Please let me know by noon Monday if you have any questions or concerns regarding this proposed location change for angle structure #73 on Basin’s Williston to Tioga 230 kV transmission line, Case No. PU-07-671. I am planning to issue staff approval Monday afternoon. Thanks.

57 PU-07-671 Filed: 6/15/2010 Pages: 2
Email Staff approval of structure moves

Project Williston/Triega Taline Project No. _____ Sheet _____ of _____
Subject Str. #73 relocation due to pipeline R/W By R. Mucha Date 6/10/10
Ckd. _____ Rev. _____

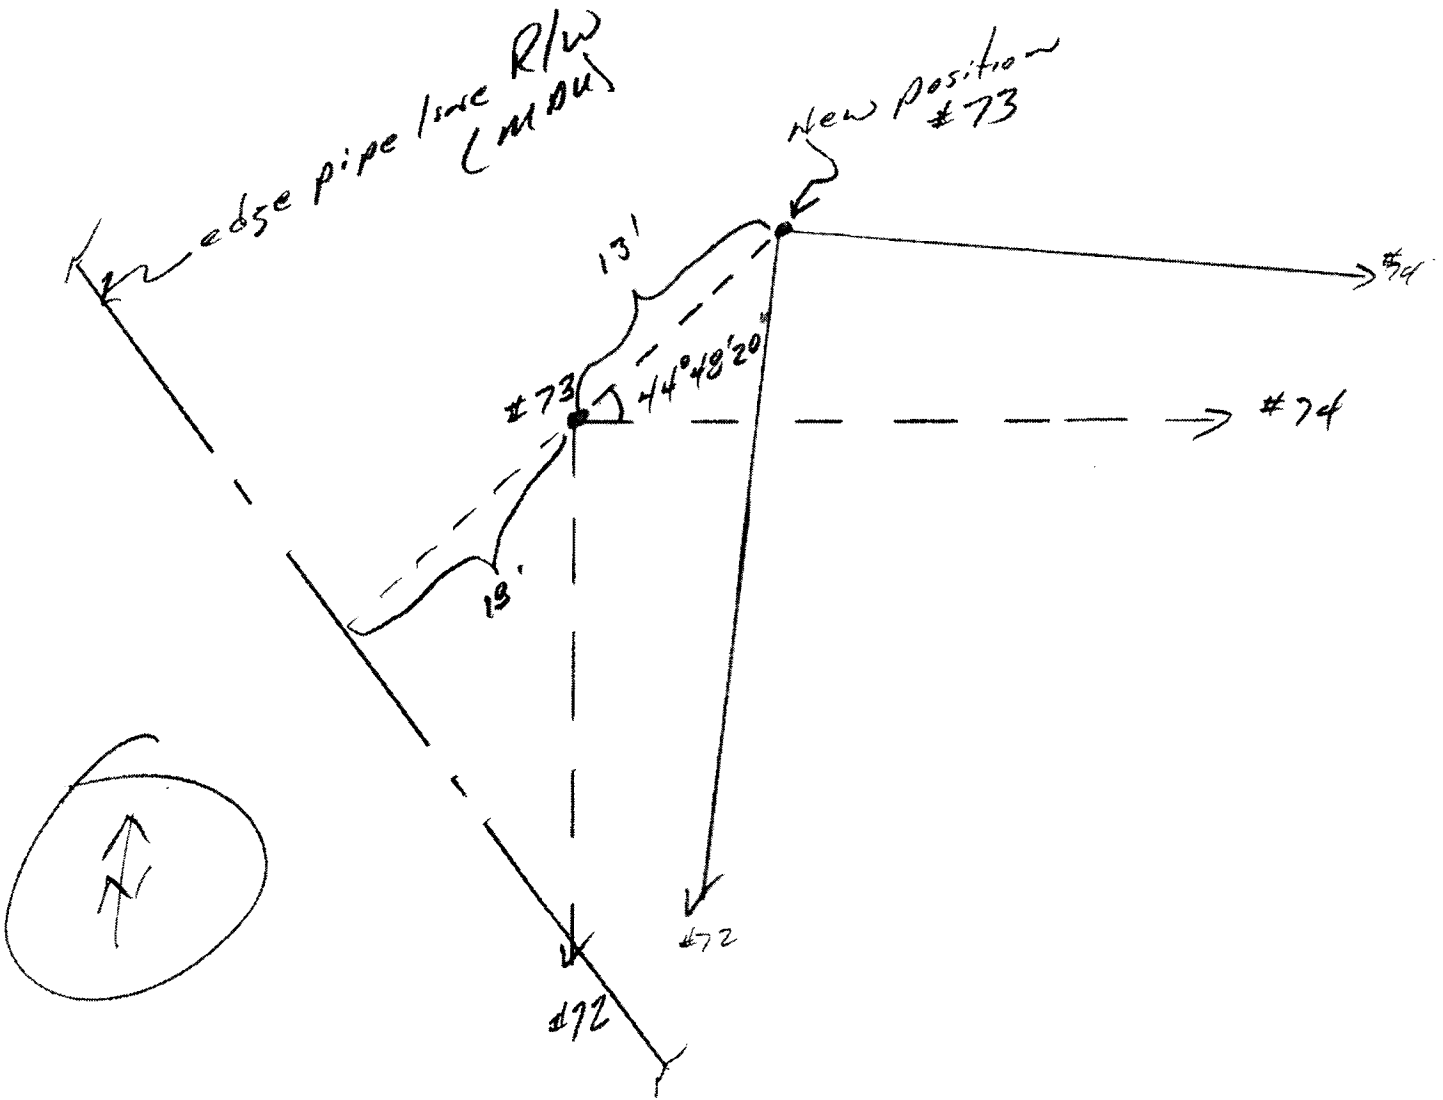
Here’s the sketch of the proposed structure move. Original structure location was 18’ from the edge of the pipeline ROW, but we are required to be 25’ away. New structure location is now 31’ from the edge of the pipeline ROW.

Note: center of structure now @ 31' from edge of pipeline R/W (25' read)

Kevin – Please consider this e-mail to be staff approval of Basin Electric’s requested structure location change. Thanks.
